**Amendment to Section V.A.
Summerlin South Community Association
Design Guidelines and Standards**

**Amendment to Section V.G.
Summerlin South Community Association
Design Guidelines and Standards**

EXHIBIT 7

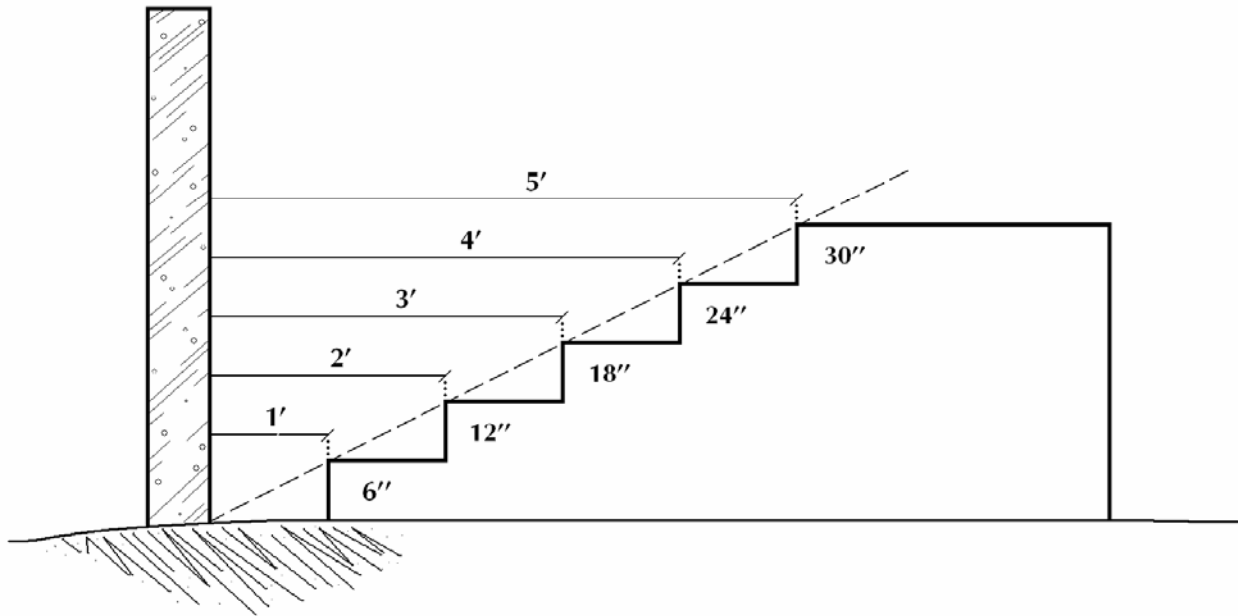
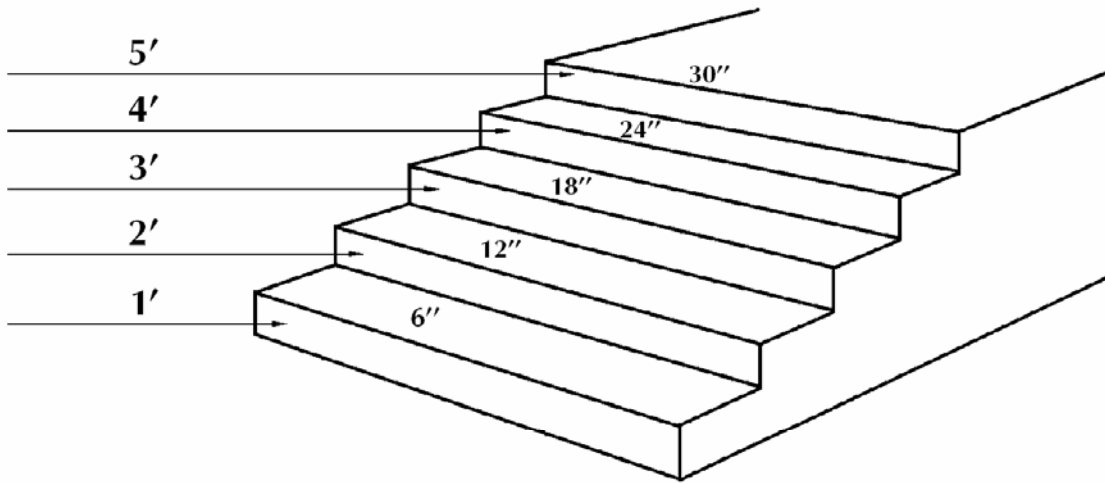
6. Raised observation decks or patios are allowed in the rear yard only.
- a. **Raised decks originating at grade level of the residence must be setback from all perimeter walls a minimum distance of twice the total height of the deck above the grade of the building pad. Except as noted in item “b” below, no deck may exceed thirty inches (30”) in height above the grade of the building pad. (refer to Exhibit 7).**

- b. Patios, decks, landings, walks, paths, waterslides/features, statuary and other hardscape improvements are allowed on the upward slope of rear and side yards, but the finished surface of the improvements shall be no higher than 2/3 (66%) of the difference in elevation between the top and the toe of the slope. The minimum setback is 10’ from all perimeter walls. Structures (including but not limited to gazebos, sheds, play equipment, fireplaces, barbeques, shade structures, etc.) on slopes are allowed, but the top of such structure may not exceed the elevation height of the top of the slope and must be set back a minimum of 10’ from all perimeter walls.
